ADDENDUM NO. 1
February 28th, 2025

**PROJECT: EULA INDEPENDENT SCHOOL DISTRICT
AG RENOVATION & ADDITION**

BID DATE: MARCH 6th, 2025 AT 2:00 PM

Nucor Buildings Group Loc Seam Standing Seam Roof Panel

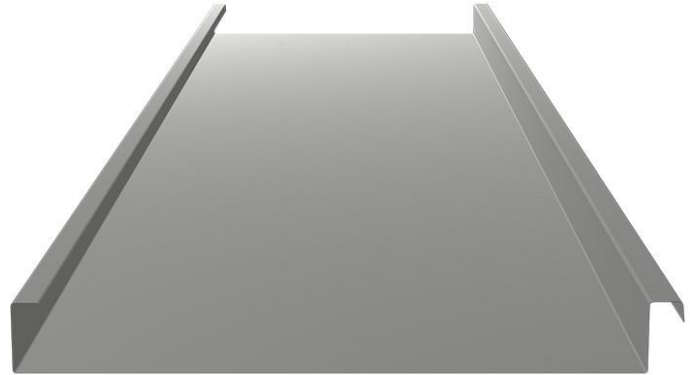
- Item #G1** See attached substitution request for Nucor Loc Seam Standing Seam Roof Panel – Approved as noted.
- Item #G2** Are the following PEMB manufactures approved: NUCOR, Mueller, Shultie. Approved with following note; GC to confirm manufacturer meets qualification requirements under IAS AC472. Must comply with specification requirements.

<input type="radio"/> Accepted	<input checked="" type="radio"/> Accepted as noted
<input type="radio"/> Not Accepted	<input type="radio"/> Received to late
By: <u>Tyler Robertson</u>	
Date: <u>2/28/2025</u>	
Remarks: <u>Must be able to be installed directly on to metal building structure, no substrate/sheathing required. Must comply with specification requirements.</u>

FLOOR PLAN

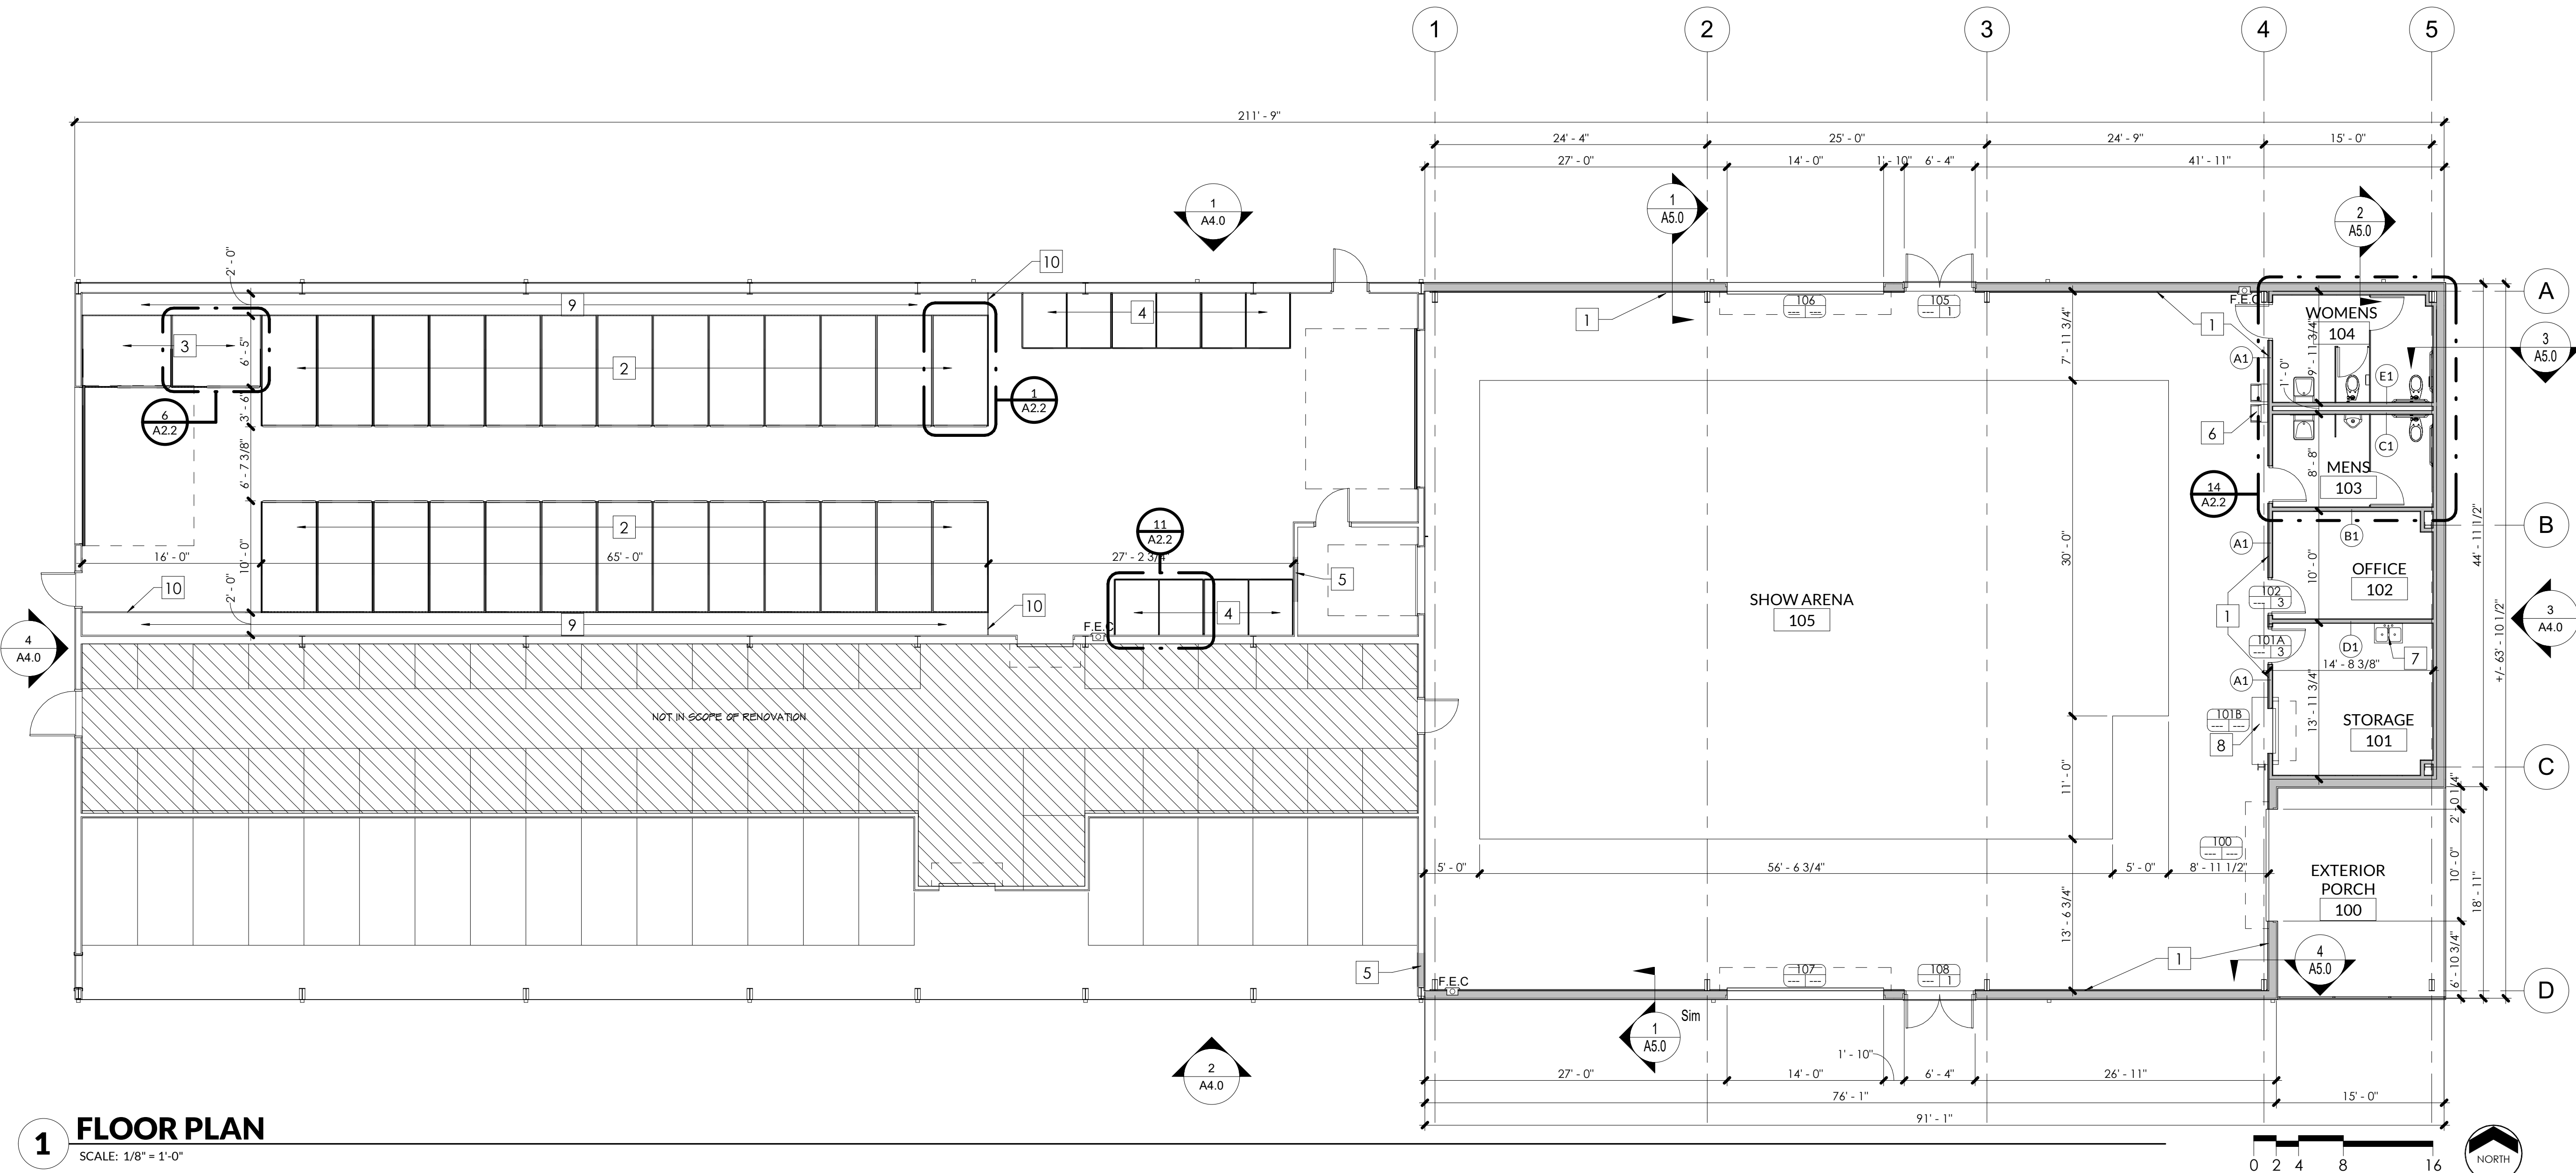
- Item #D1** Sheet A2.1 – REPLACE sheet with attached sheet A2.1 dated 02-28-202. UPDATED keyed note 10.
- Item #D2** Sheet A2.2 – REPLACE sheet with attached sheet A2.2 dated 02-28-2025. ADDED missing elevations. UPDATED Duraplate note.
- Item #D3** Sheet E1.0 – REPLACE sheet with attached sheet E1.0 dated 02-28-2025. UPDATED general power notes.

- 1 METAL LINER PANEL UP TO 8' - 0".
- 2 ANIMAL PENS; 5' - 0" W X 10' - 0" D, SEE TYPICAL DETAIL.
- 3 ANIMAL WASH BAYS; 8' - 0" W X 6' - 6" D, SEE TYPICAL DETAIL.
- 4 LOCKERS; 4' - 0" W X 5' - 0" D, SEE TYPICAL DETAIL.
- 5 METAL BUILDING INFILL.
- 6 DRINKING FOUNTAIN, REFER TO PLUMBING.
- 7 DOUBLE SINK, REFER TO PLUMBING.
- 8 SOLID SURFACE COUNTER TOP.
- 9 SLOPED SLAB, REFER TO STRUCTURAL.
- 10 ADD ANIMAL PEN PANELING, REFER TO DETAILS 16/A2.2 AND 17/A2.2.

ENLARGED FLOOR PLANS

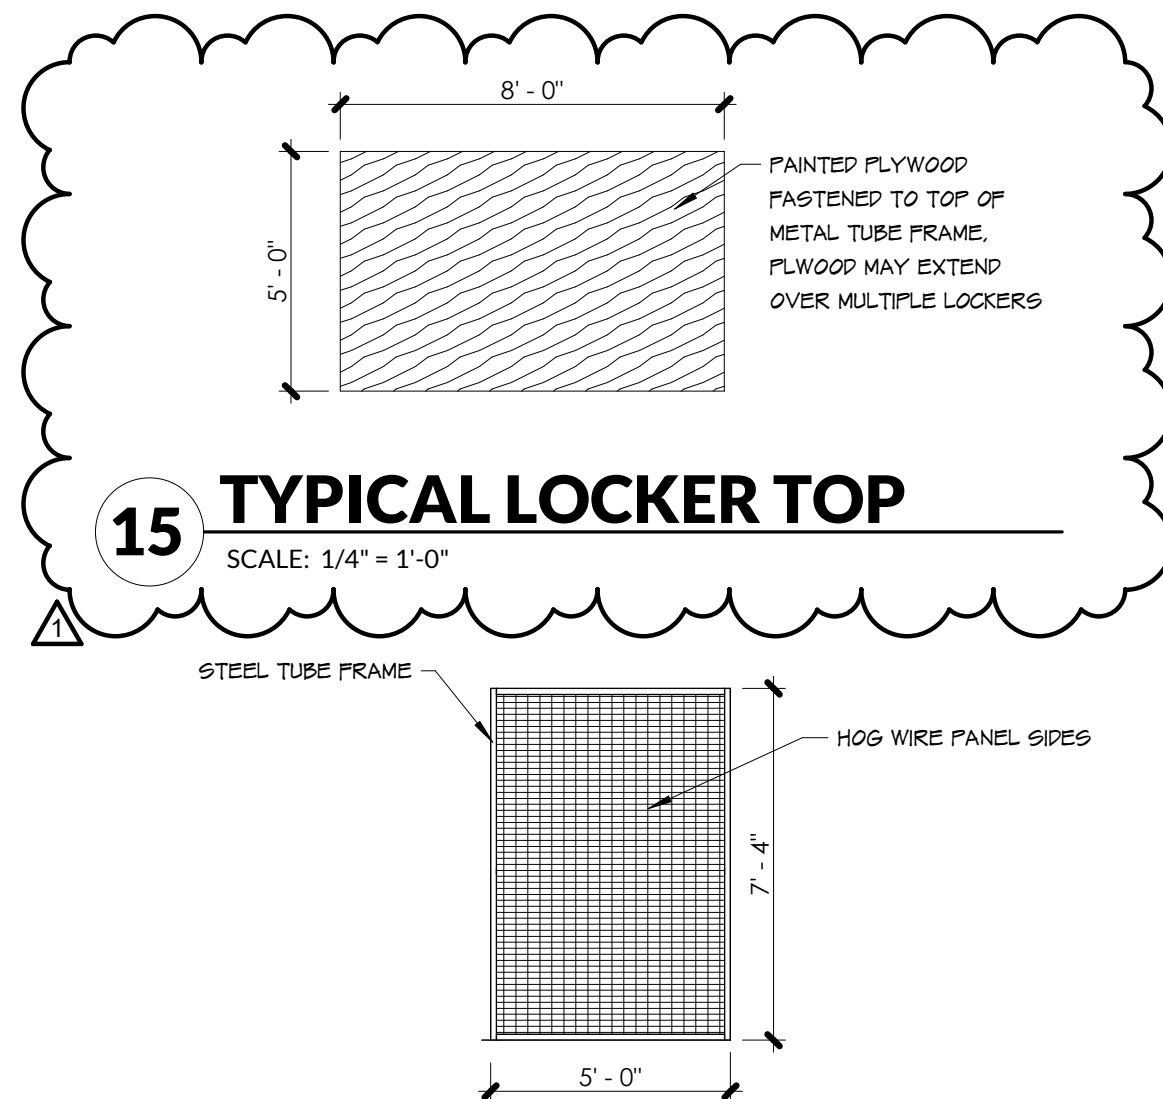
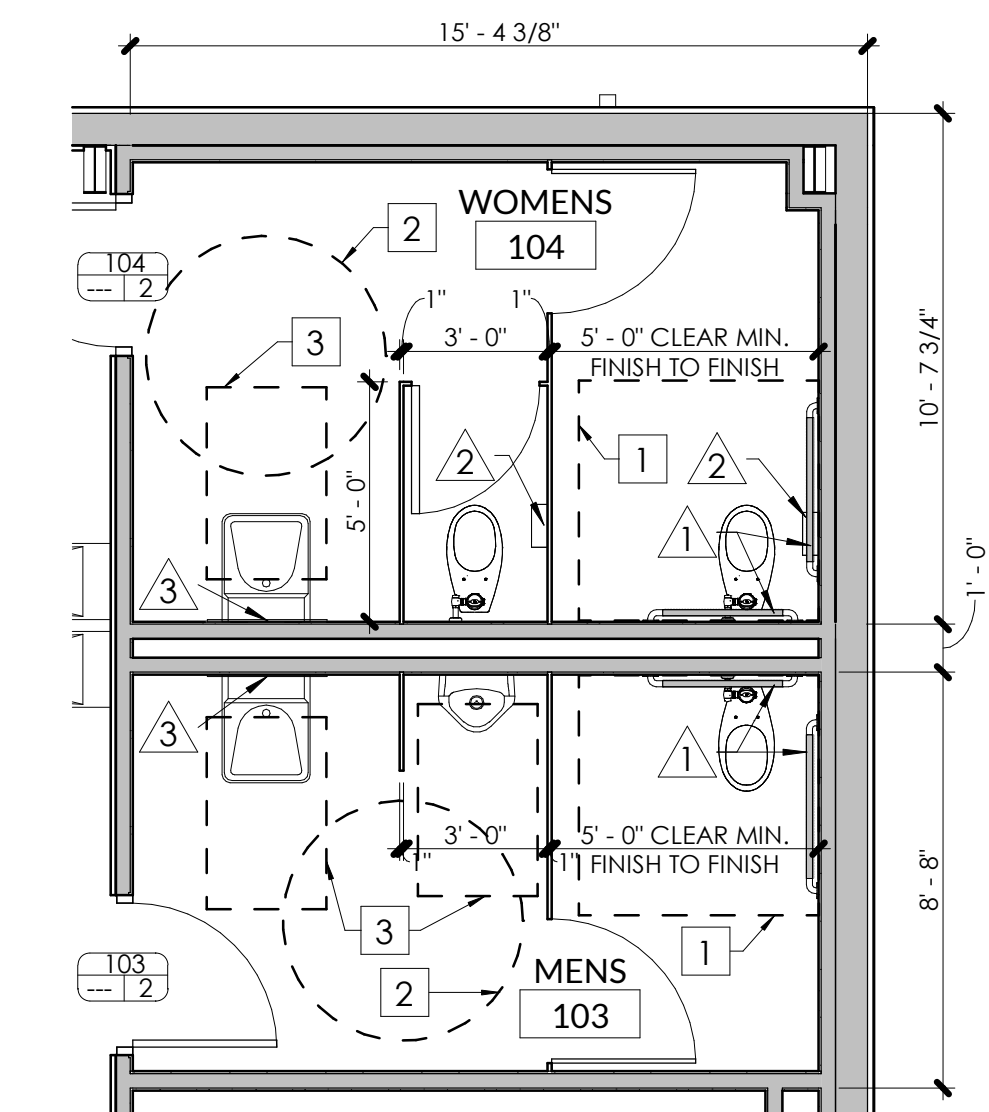
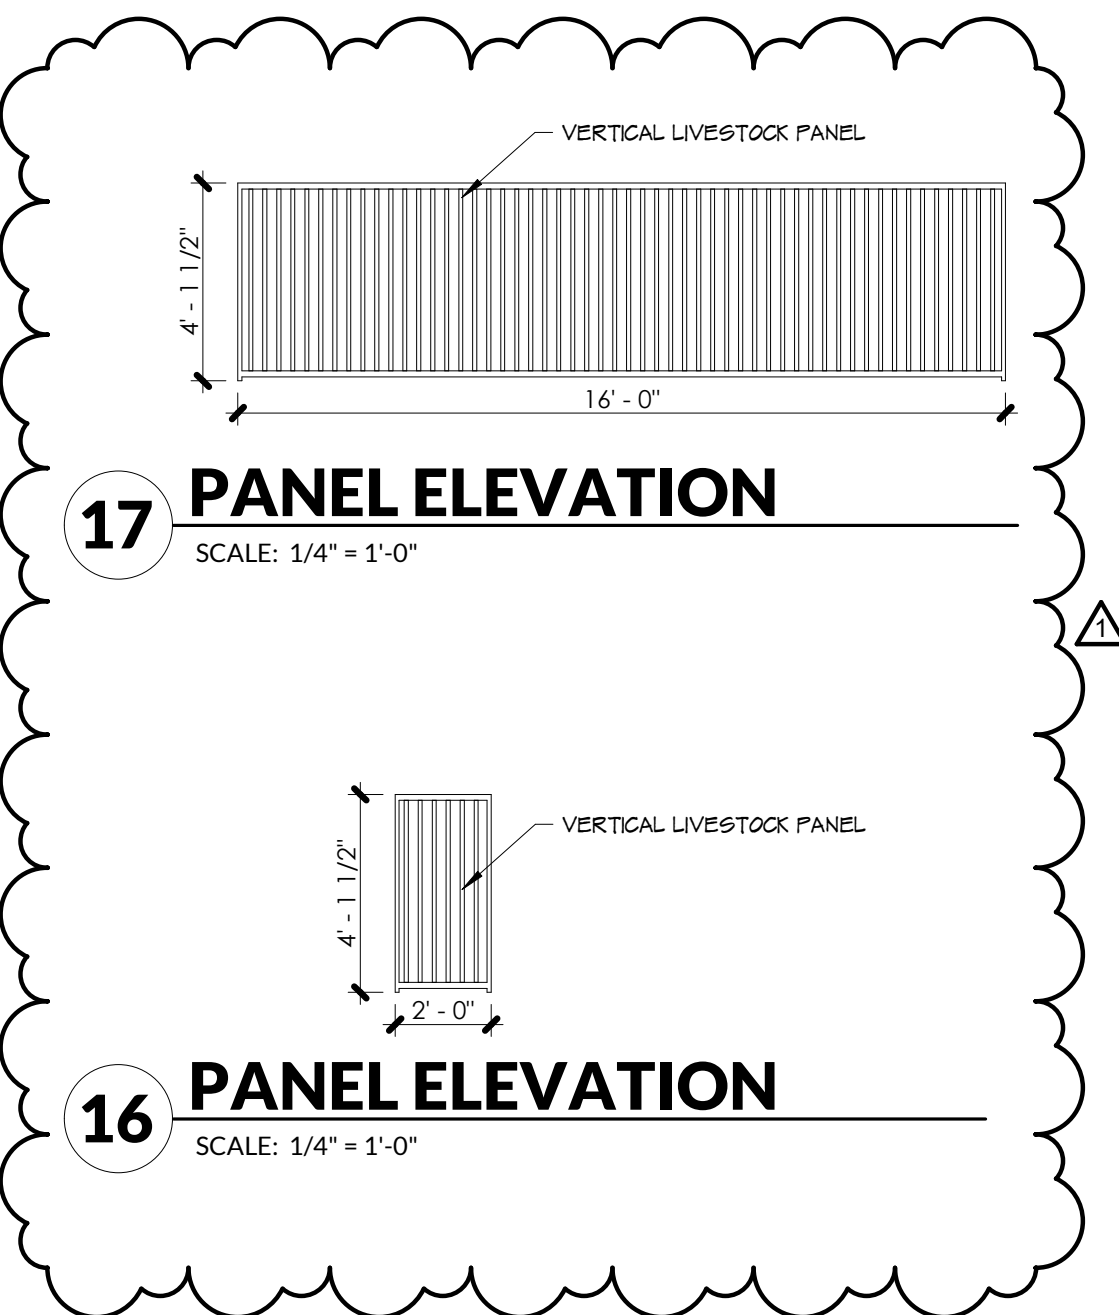
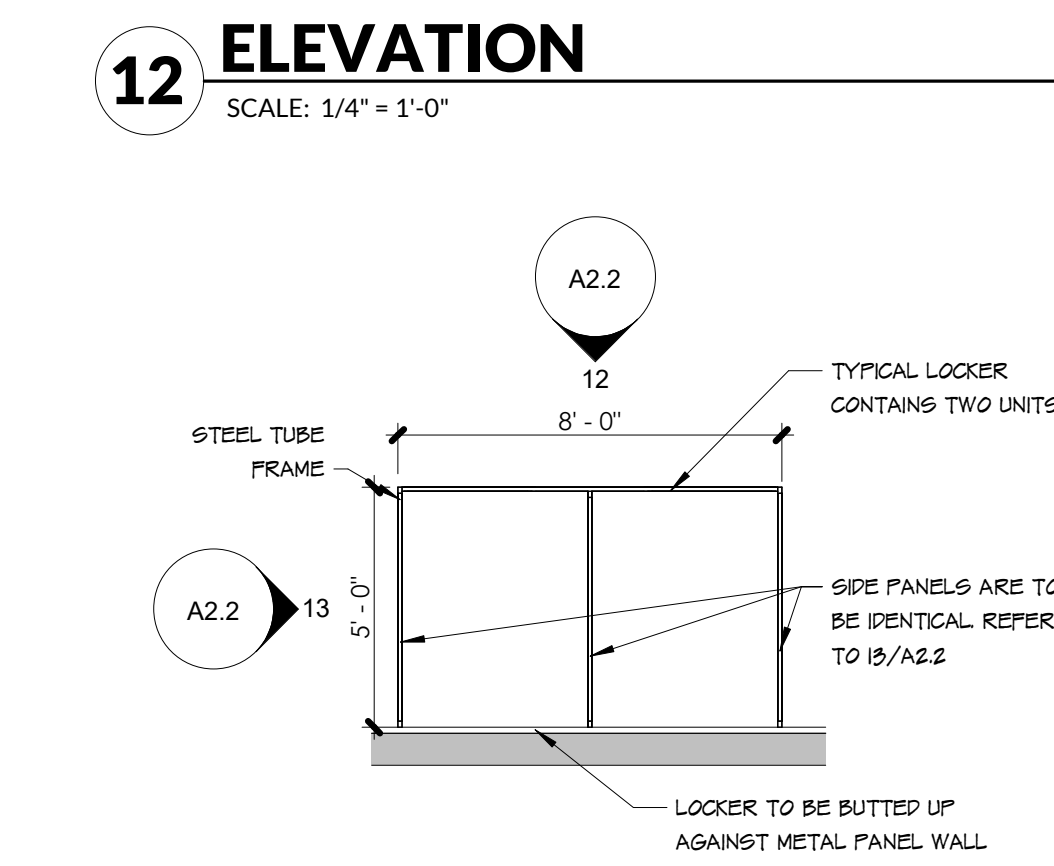
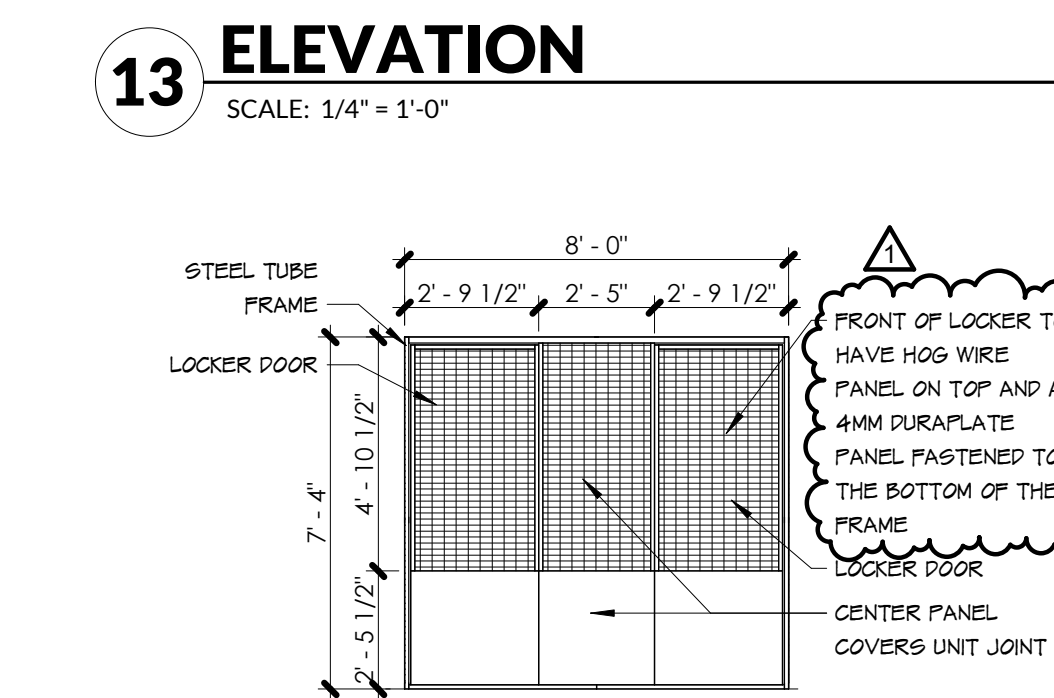
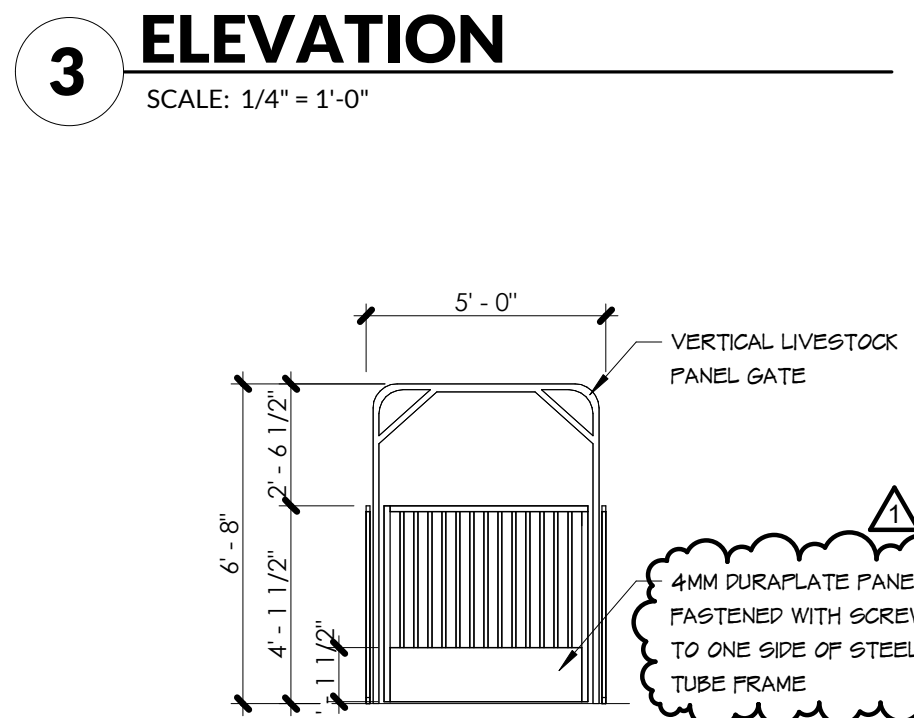
- Item #Q11** **Question:** Elevations 4 & 9 on A2.2; is Duraplate paneling required on both sides of the animal pen panels?
- Answer:** No; it is a single Duraplate panel (Duraplate is a double sided product) that is fastened to the steel tube frame. This matches the existing condition at the current animal pens. See updated architectural sheet.
